Addendum No. 002

**Subject:** Anna B. Day School – Fire Alarm System Replacement SDP  
Contract No. B-081C of 2018/19

**This Addendum, dated May 24, 2021, shall modify and become part of the Contract Documents for the work of this project. Any items not mentioned herein, or affected by, shall be performed strictly in accordance with the original documents.**

DRAWING NO.  
**E - 101.0**  
SHEET 6 OF 8

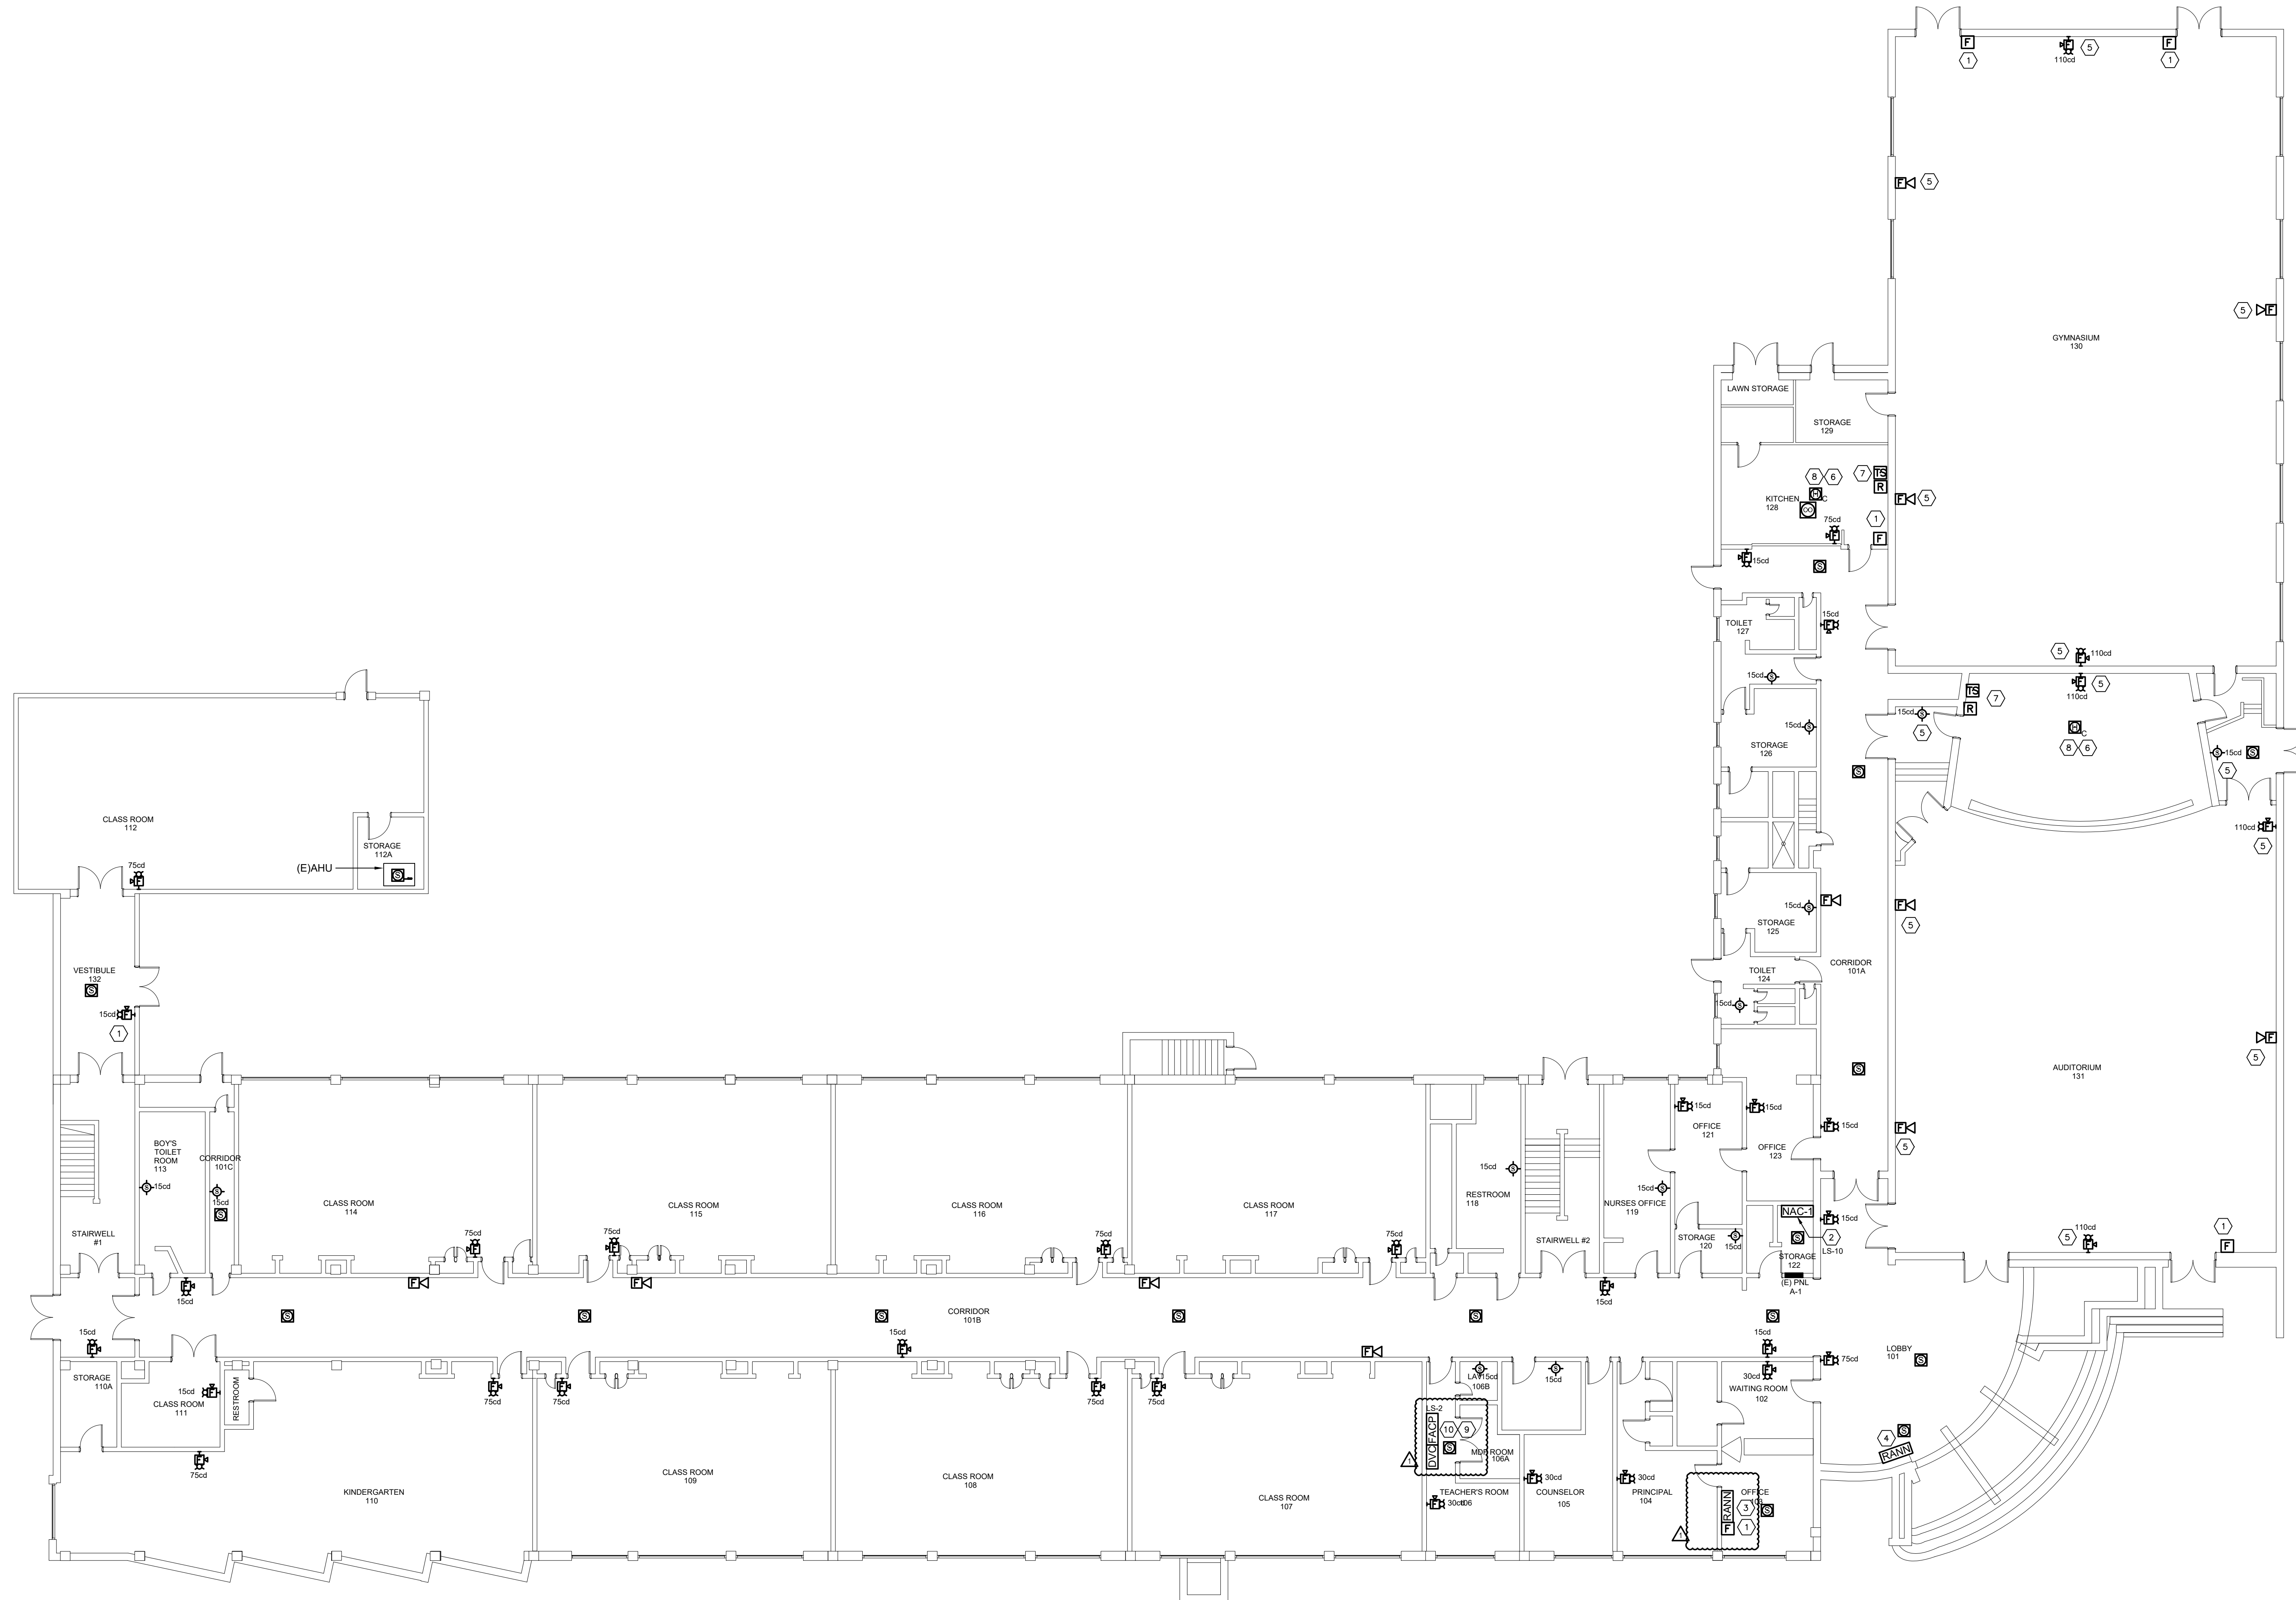
E101:

1. Updated location of fire alarm control panel (FACP).
2. Added smoke detector at FACP location.

Question #5: Summary of work spec section 011000-1.3(9) states to provide smoke detector above the FACP, but a smoke detector is not shown in room Principal 104 on drawing E101.0. Please confirm a smoke detector should be placed in that room.

Response – The location of the fire alarm control panel has been updated. Yes a smoke detector is required at the location of the FACP. See revised drawing E101.

DRAWING NO.  
**E - 102.0**  
SHEET 7 OF 8

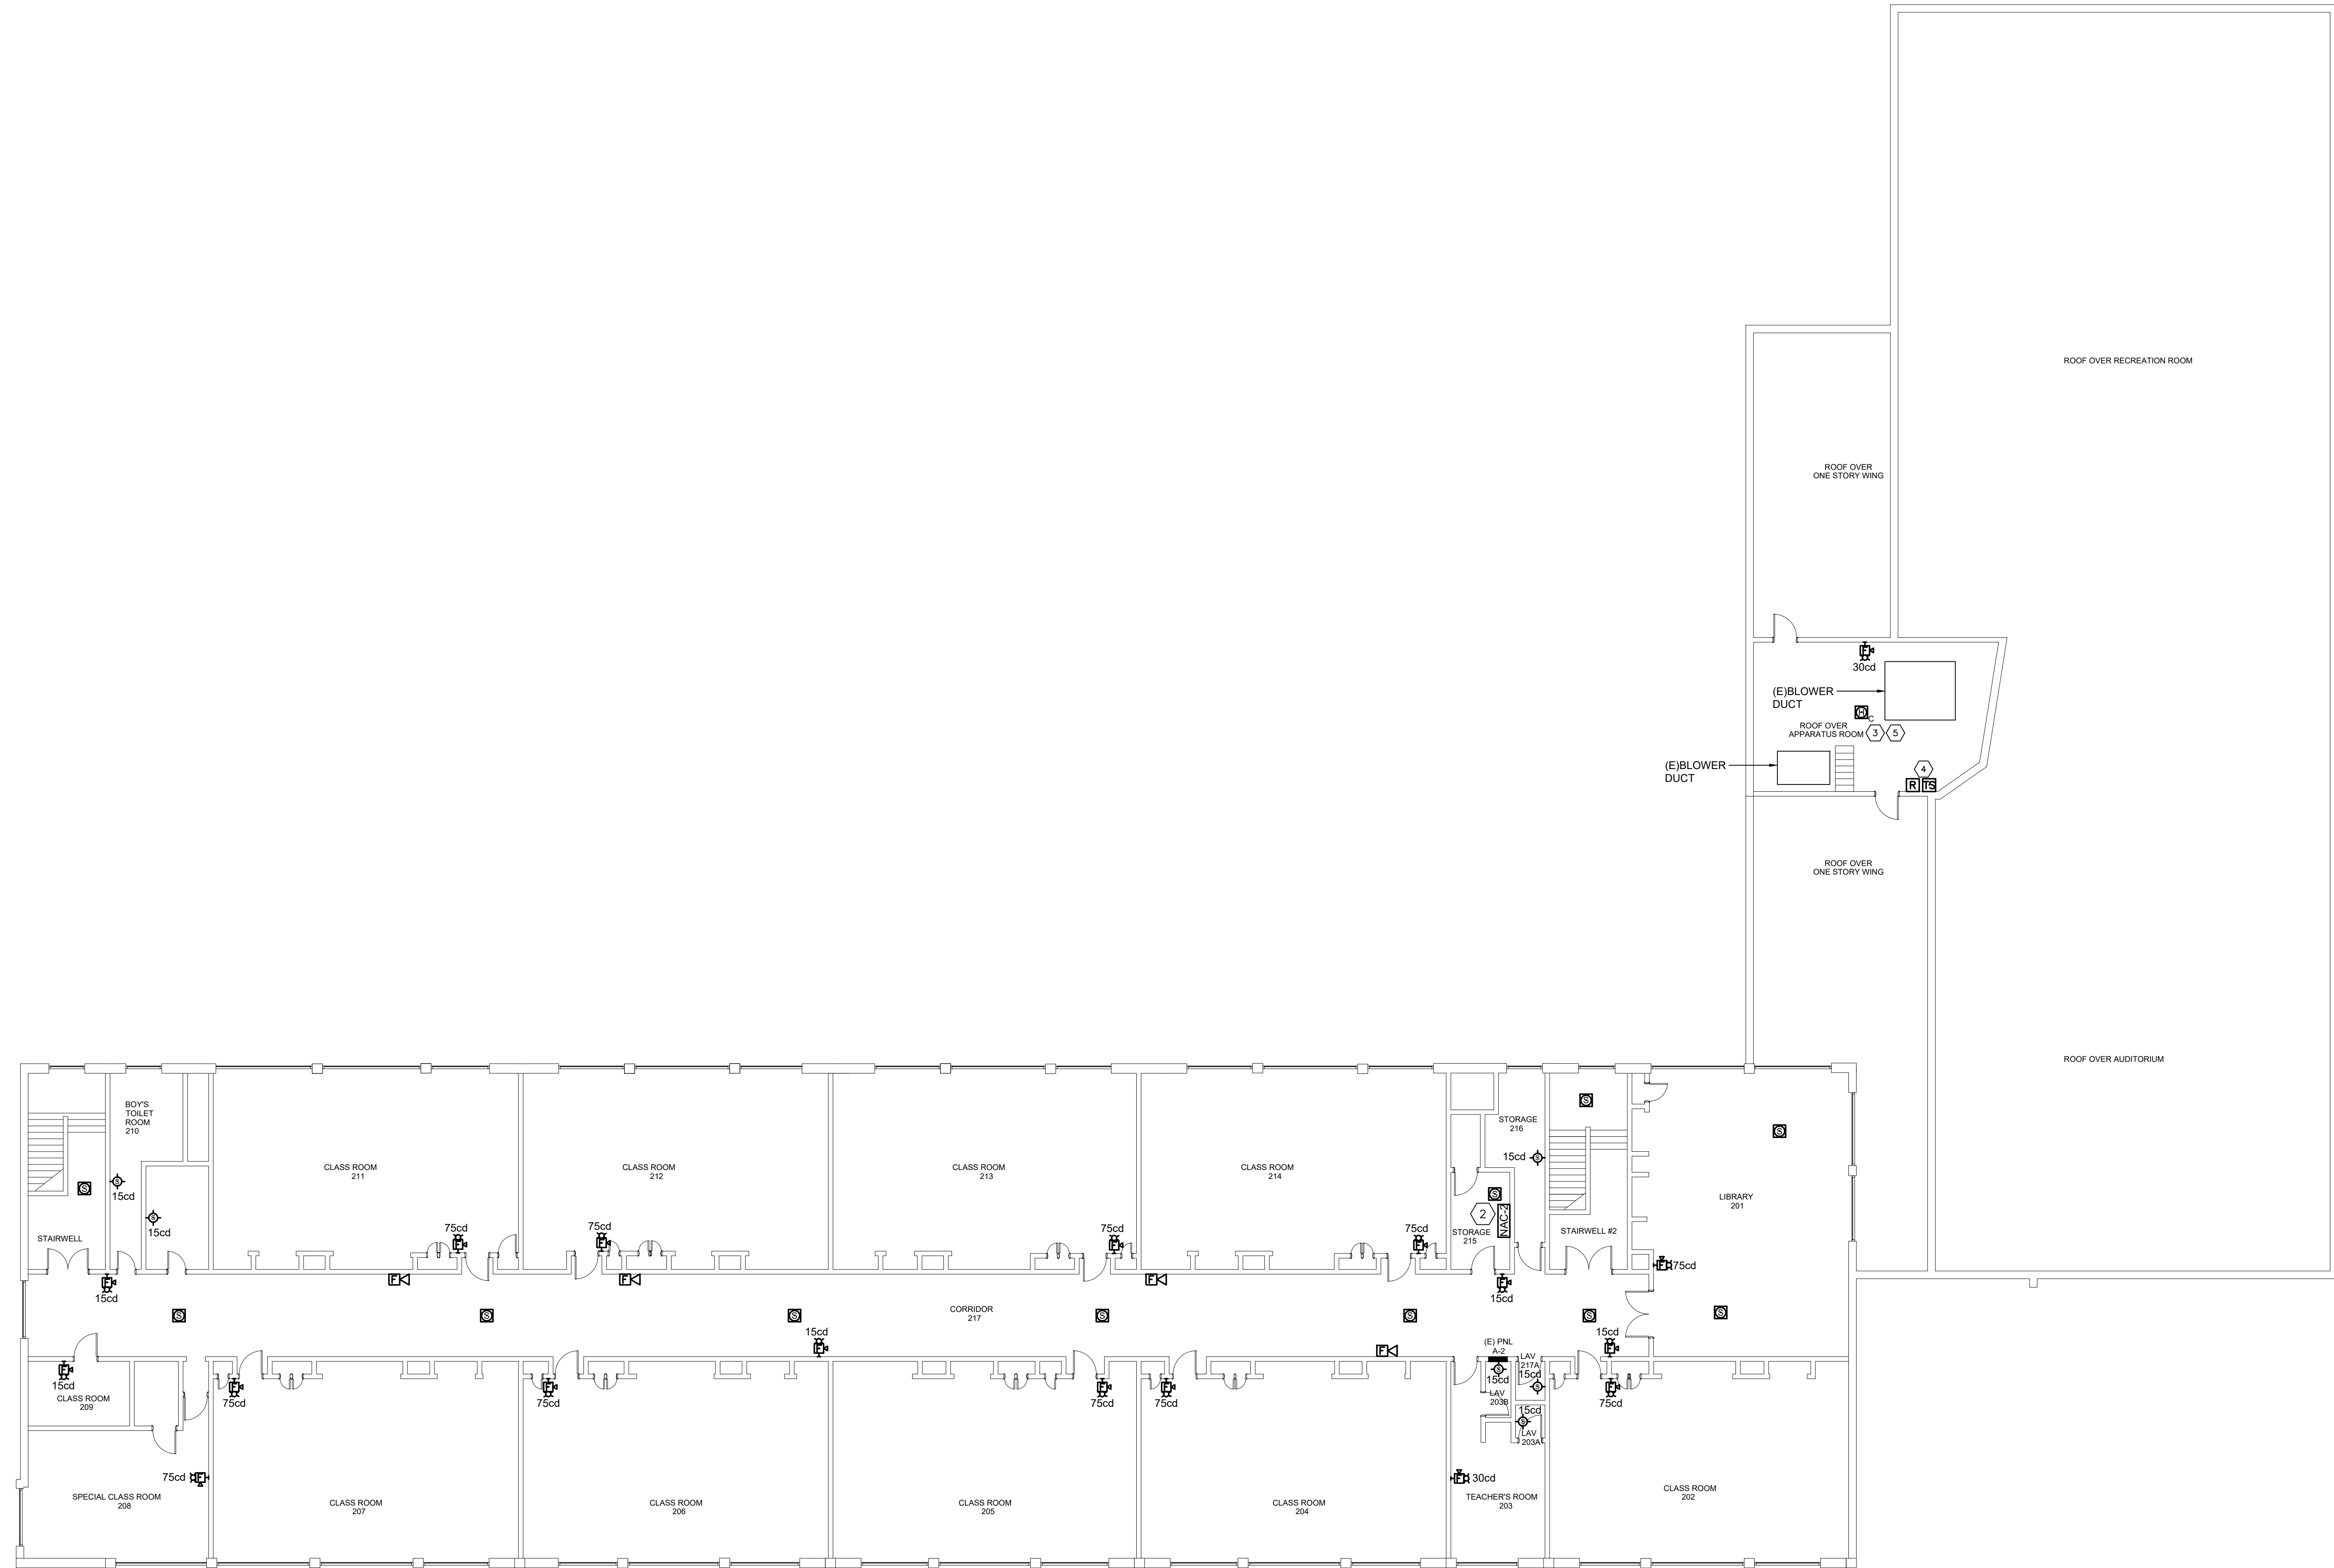
Question #1: Spec 011100 states that contact with asbestos containing materials is not anticipated for this project. General note A on drawing E-100.0 states to avoid asbestos containing materials per the provided report, and there should be no cost to the school district if devices need to be relocated to avoid asbestos containing materials. However, there may be instances where we cannot relocate and may need to abate, but this scope cannot be quantified until construction begins. Therefore, this note is unbidable. Please consider adding an allowance for asbestos abatement or removing the "no cost" portion of general note A.

Response – DELETE NOTE A ON DRAWING E-100 AND NOTE F ON DRAWINGS E-101 AND E-12, AS WELL AS NOTE F ON DRAWINGS ED-100, ED-101 AND ED-102.
